802.1 maintenance item 0319: Race condition in 802.1Q-2018 between List Config state machine (clause 8.6.9.3) and Cycle Timer state machine (clause 8.6.9.1)

Alon Regev

AUG 11, 2021

Proposed fix – part 1

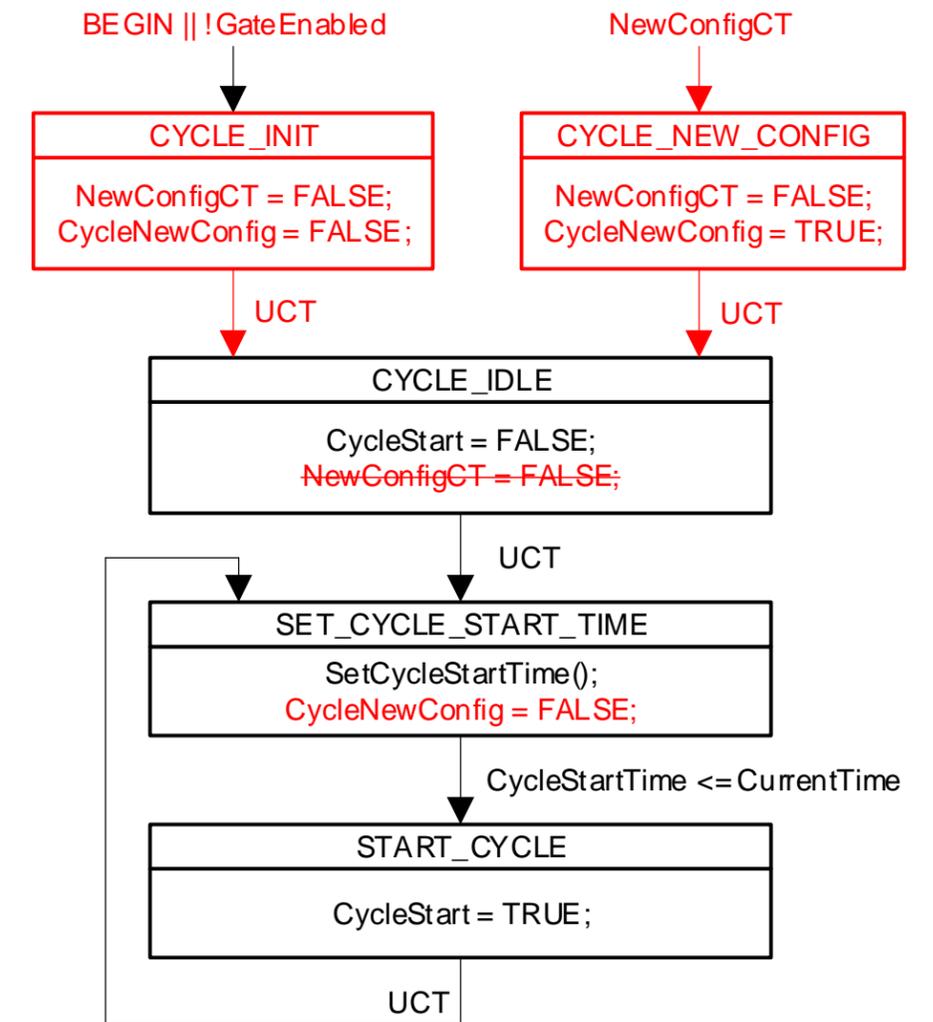
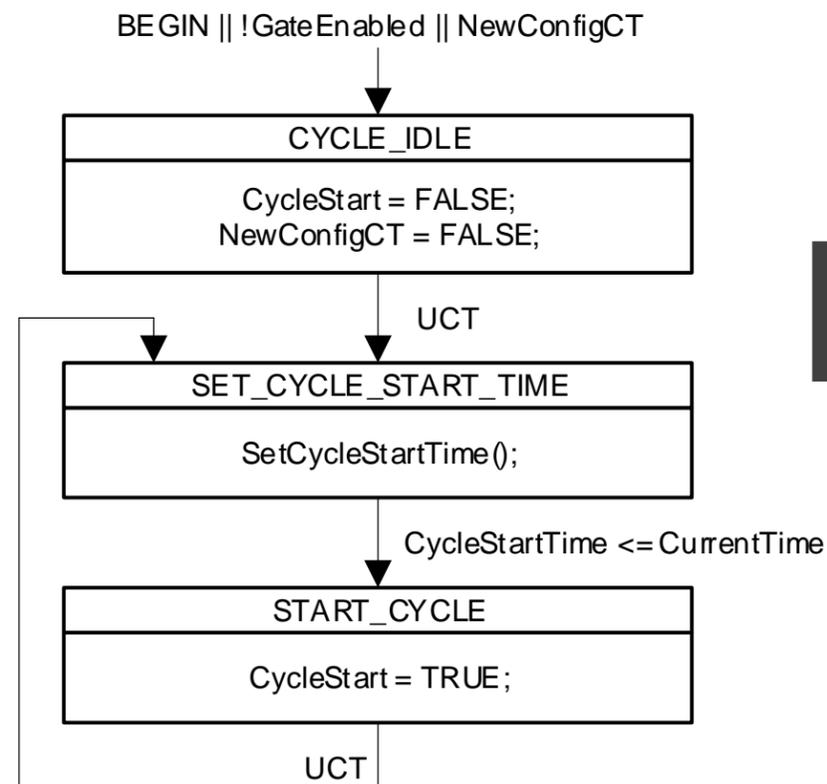
- In Clause 8.6.9.1 , Figure 8-19 (Cycle Timer State Machine):
 - Remove the global transition from “BEGIN || !GateEnabled || NewConfigCT” to CYCLE_IDLE
 - Add a new state named “CYCLE_INIT”
 - This state will contain the “NewConfigCT = FALSE;” and “CycleNewConfig = FALSE;”
 - Add a global transition from “BEGIN || !GateEnabled” to the new CYCLE_INIT state
 - Add a new state named “CYCLE_NEW_CONFIG”
 - This state will contain the “NewConfigCT = FALSE;” and “CycleNewConfig = TRUE;”
 - Add a global transition from “NewConfigCT” to the new CYCLE_INIT state
 - Add an UCT transition from the CYCLE_INIT state to the CYCLE_IDLE state
 - Add an UCT transition from the CYCLE_NEW_CONFIG state to the CYCLE_IDLE state
 - Remove the line “NewConfigCT = FALSE;” from the CYCLE_IDLE state
 - In the SET_CYCLE_START_TIME, after “SetCycleStartTime()” add a new line containing “CycleNewConfig = FALSE;”
